HORNSEA PROJECT THREE OFFSHORE WIND FARM

Planning Inspectorate Reference: EN10080

**Annex D4: JNCC and Natural England advice on offshore benthic  
ecology**

7 November 2018

Fig 1: Annex 1 reef layer v8 (area to be managed as reef).

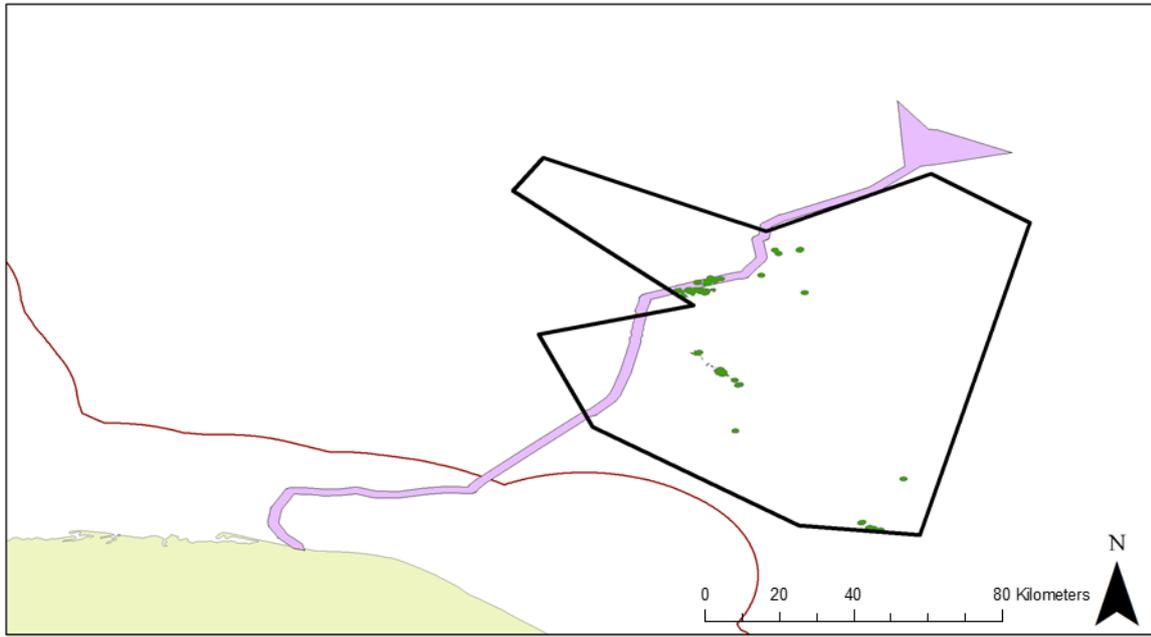
- 4.13. We acknowledge that the applicant considers that *Sabellaria* biotopes have a wide distribution throughout the southern North Sea benthic ecology study area. We agree with this, but we would not agree that Annex I *Sabellaria* reef has a wide distribution in the area (Figure 1).

Fig 2: Annex 1 reef layer v8 (area to be managed as reef), Saturn Reef detail showing reef and Hornsea 3 cable corridor.

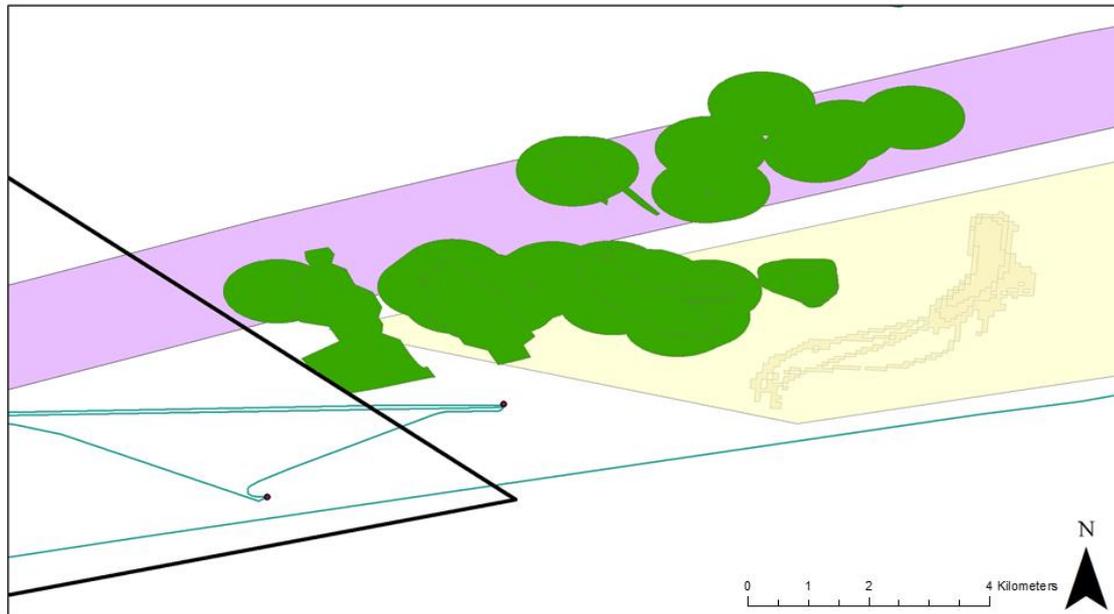
- 4.14. JNCC have particular concerns over the section of offshore cable routing next to Saturn Reef as we are unsure as to whether the applicant can microsite around the reef feature in this area (Fig 2).
